Staff Responses to Council Questions

February 20, 2018

A-C. Ordinances and a Resolution for a Planned Unit Development, Special Use and Final Plat of Subdivision for 2001 63rd Street

63RD STREET AND WOODWARD AVENUE
 VILLAGE OF DOWNERS GROVE, ILLINOIS
 EXTERIOR ELEVATIONS

Revised east elevation rendering

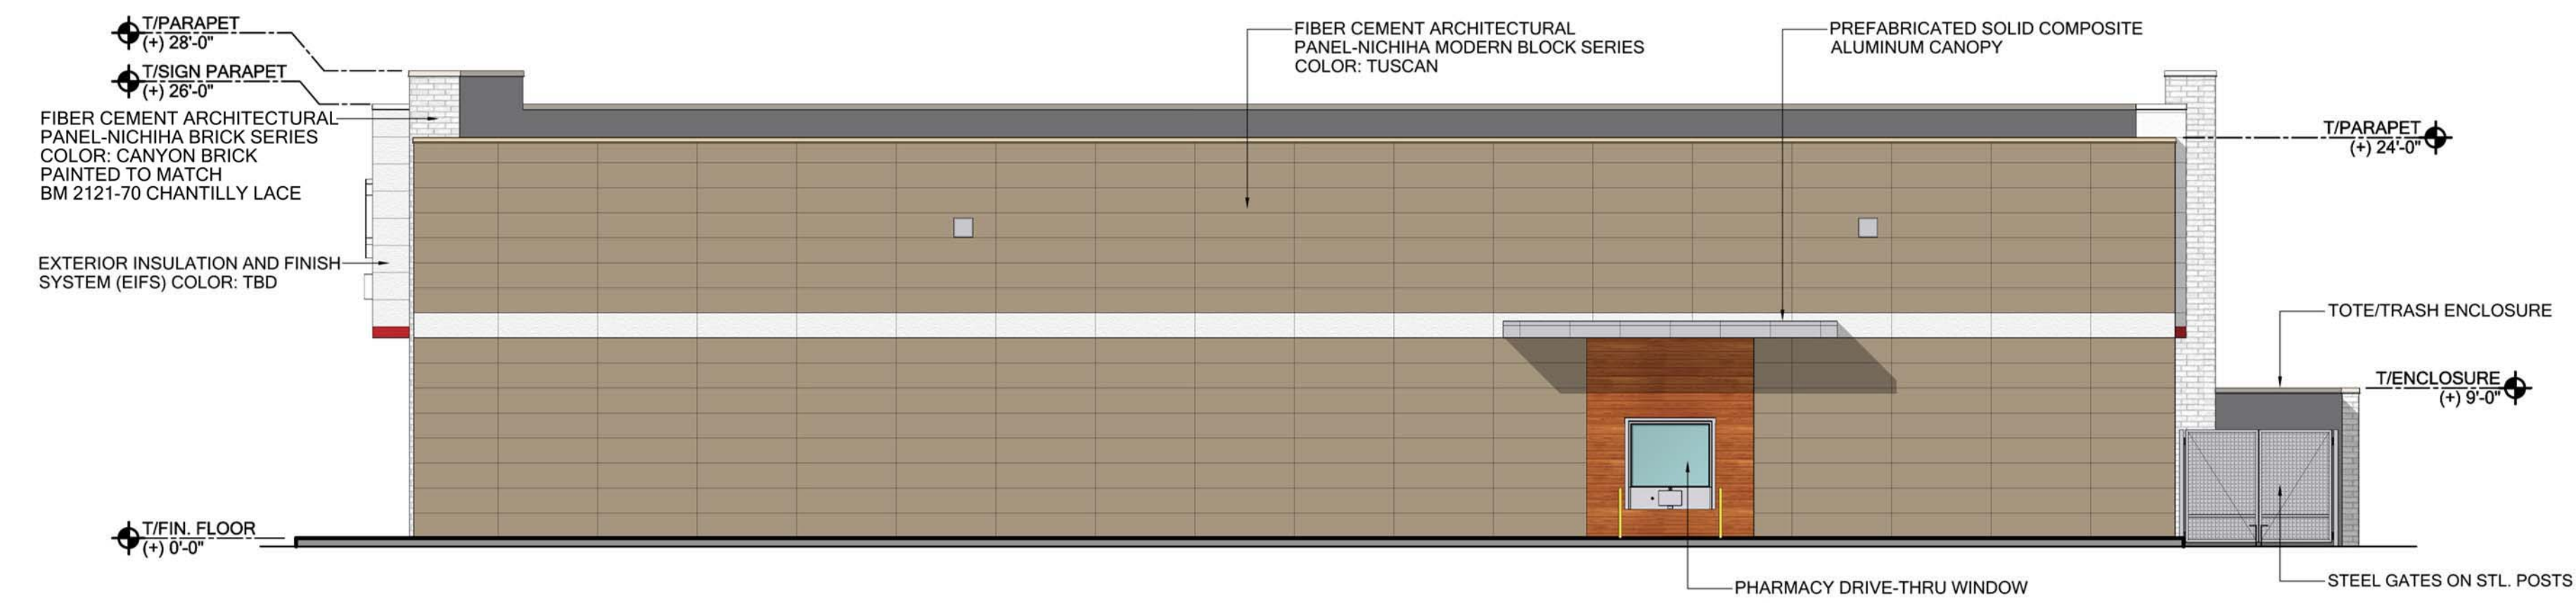
Why is Staff recommending reinstatement of Condition 6? What is the alternative and advantage/disadvantage? Why extend the EIFS overhang?

Did the Plan Commission indicate why they did not support the staff recommendation to carry the white building design element around the building?

Staff condition #6 requires the applicant to extend the overhang the entire width of the east elevation. As shown in the attached revised elevation plan, staff recommends extending the overhang on the east elevation to provide enriched architectural variety to a street facing wall at a major corner intersection. As currently proposed, staff finds this facade more closely resembles a rear elevation along a street. The overhang extension will assist the east facade in appearing more like a front facade.

The alternative would be to allow the fiber cement board to extend from the base of the building to the top of the building. From a construction standpoint, there is no advantage or disadvantage to either material. As noted above, it is an aesthetic request to have the east elevation appear more like a front facade.

The Plan Commission was satisfied with the aesthetic appearance of the east facade and felt the overhang extension was unnecessary.
